Application No.: 09/472,134

Title: SNOWMOBILE

REQUEST FOR APPROVAL OF DRAWING CHANGES

FIG. 1

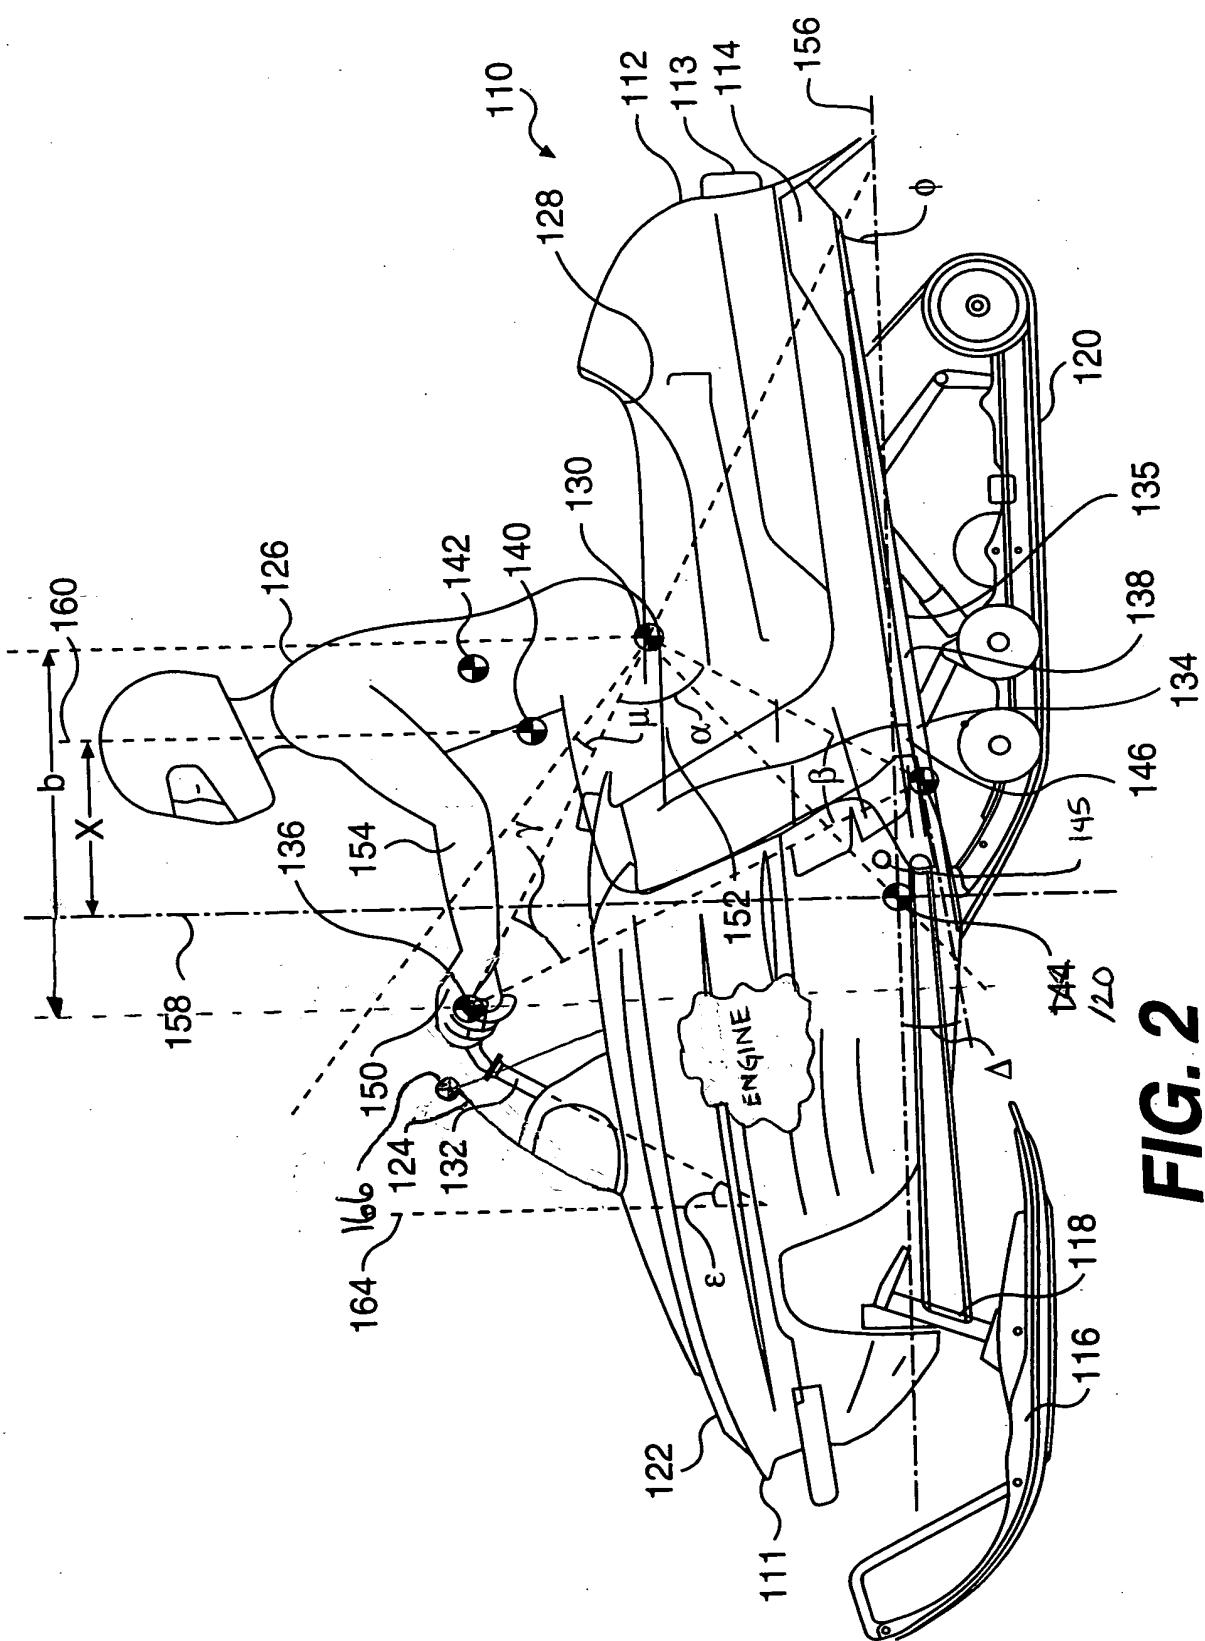
Finally, Applicants have amended FIG. 1 to add the label "PRIOR ART." Applicants believe that the addition of this label to FIG. 1 addresses the Examiner's objection as set forth in paragraph #3 of the Office Action.

FIG. 2

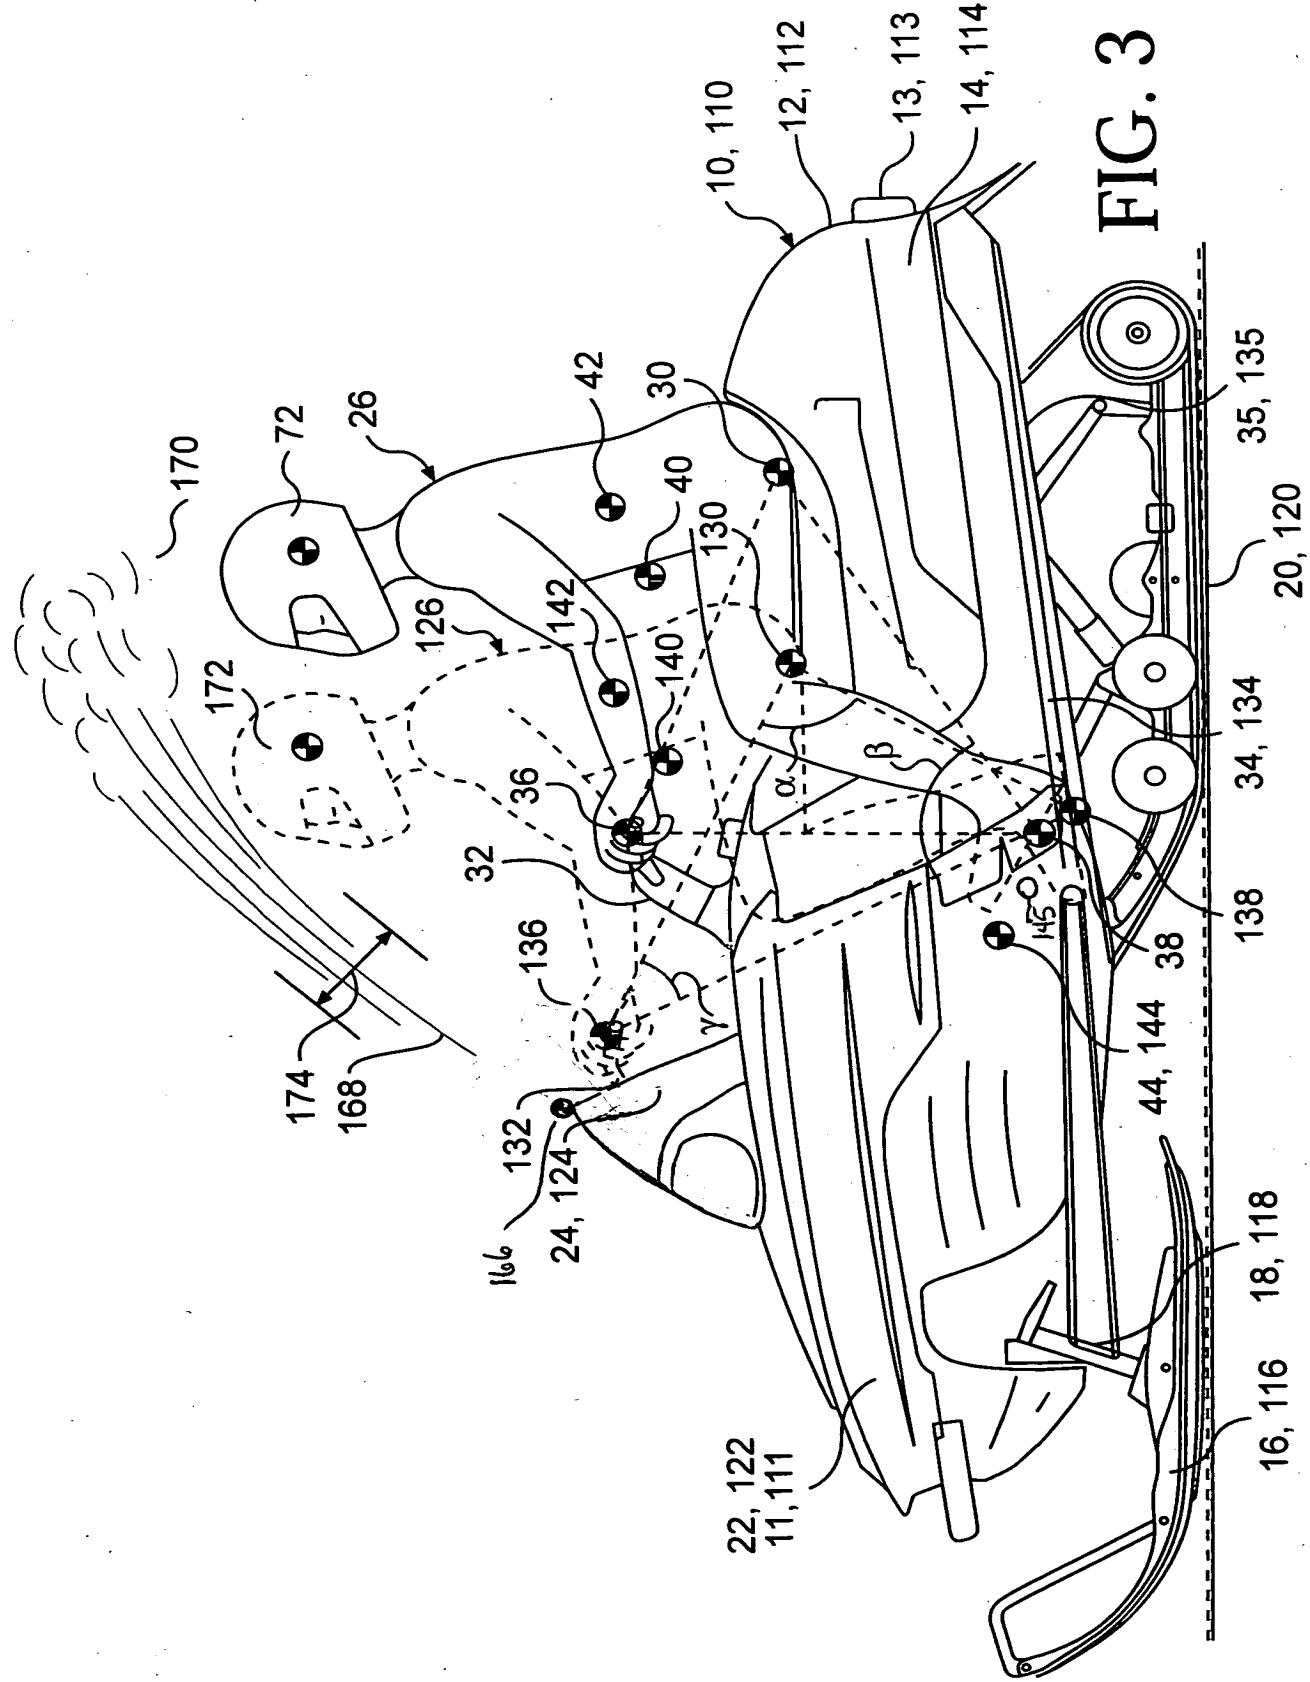
Subject to approval by the Examiner, Applicants propose to amend the drawings as indicated in red in the copies of the drawings attached hereto.

Specifically, Applicant's have amended FIG. 2 as follows: (1) to redraw the windshield so that it does not interfere with the movement of the handlebars; (2) to insert an indication of the location of the engine; (3) to renumber the drive track from "144" to --120--; (4) to illustrate and label toeholds 145; and (5) to redraw the distance, b, between the steering position and the seat position (as defined in FIG. 11). Further, Applicants have amended FIG. 3: (1) to redraw the windshield so that it does not interfere with the movement of the handlebars; and (2) to illustrate and label the location of toeholds 145. Also, Applicants have amended FIG. 14 to indicate that angle ϵ is measured from the vertical and not the horizontal, as shown. Applicants believe that these changes address each of the comments and objections set forth in paragraphs 1-2 of the Office Action dated march 22, 2000.
